Appl. No. 10/045,515  
Amdt. dated March 7, 2005  
Reply to Office Action of December 13, 2004

**Amendments to the Drawings:**

Inventors: Tsutomu Tanaka et al.  
Application No.: 10/045/515  
Attorney Docket: 016301-040100US  
Annotated Sheet Showing Changes for Figs. 7A - 7D

Fig. 7D

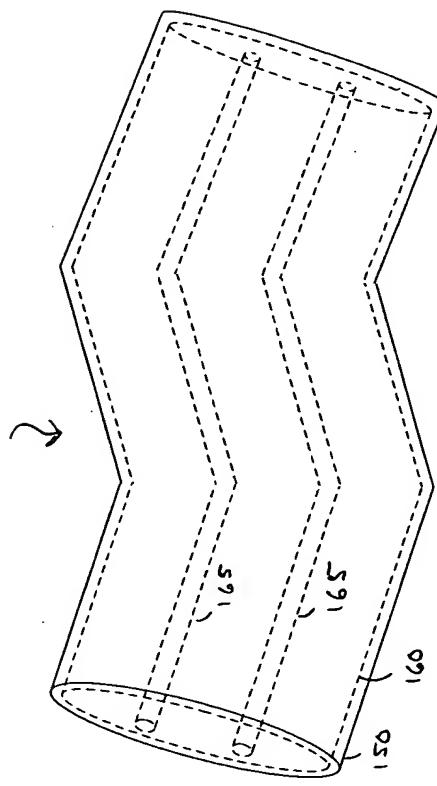
The attached sheet of drawings includes added Fig. 7D. This sheet, which includes Figs. 7A - 7D replaces the original sheet that includes Figs. 7A - 7C.

The drawings are objected to under 37 CFR 1.83(a) as the drawings must show every feature of the invention specified in the claims. Fig. 7D has been added to address the objection. Fig. 7D adds no new matter to the application as originally filed. Support for Fig. 7D may be found in the specification as originally filed at page 6, lines 10-13, and in originally filed Fig. 7A among other places. Specifically, the embodiment of the invention shown in Fig. 7A is described in the specification, as originally filed, as being bent into spirals, coils, or serpentines. Fig. 7D merely shows the embodiment of Fig. 7A as serpentine. The attached replacement drawing sheet includes Figs. 7A - 7D and replaces the original drawing sheet that includes Figs. 7A - 7C. Applicant respectfully requests the Examiner enter the replacement drawing sheet as no new matter is added to the application.
